URBAN DESIGN CONSULTATION RESPONSE

Design Officer	Azhar Kapadi
Date	14.08.25 Review of amendments following earlier formal consultations
Application Reference	24/01120/FUL
Address	Lancashire Dog Training And Behaviour Centre , Bamford Road, Heywood, Rochdale, OL10 4TF
Proposal	Demolition of existing building and erection of three storey building comprising 6no. two bed apartments with associated car parking, boundary treatments, bin store and landscaping

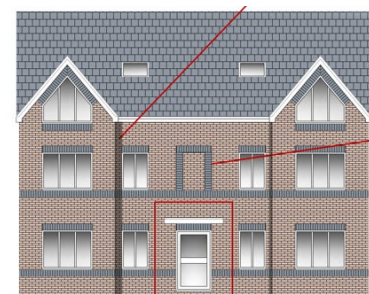
better off as a recessed window - see precedent

Building requires some depth and articulation. BRICK DETAILING is a must - see precedents.

Concerns with front entrance have not been addressed. Prior entrance and welcome to building along main elevation.

PROPOSED FRONT ELEVATION

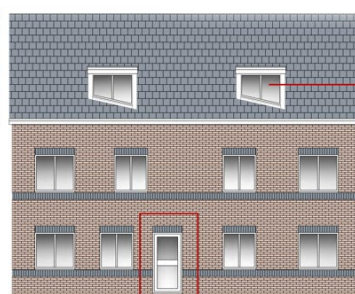
Looks bizarre but will be with planning officer to conclude

What is the recess depth? windows?

Building requires some articulation. BRICK DETAILING is a must - see precedents.
Alternative but not fully inspired. Reconsider how inspection, the be done with it

PROPOSED SIDE ELEVATION 1

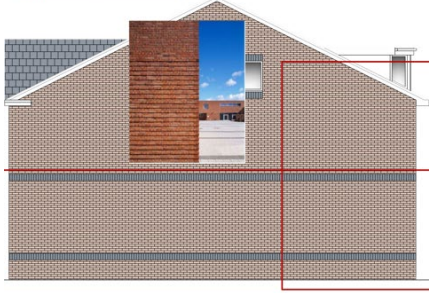
Do not present unattractive, dark, elements at the street

PROPOSED SIDE ELEVATION 2

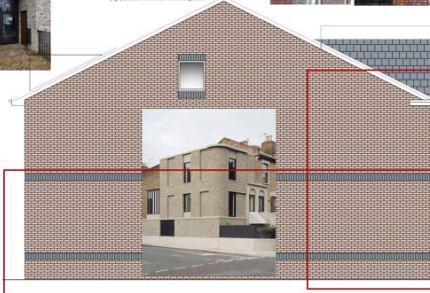
Design process shows improvement but emphasises the necessity for a pre-app
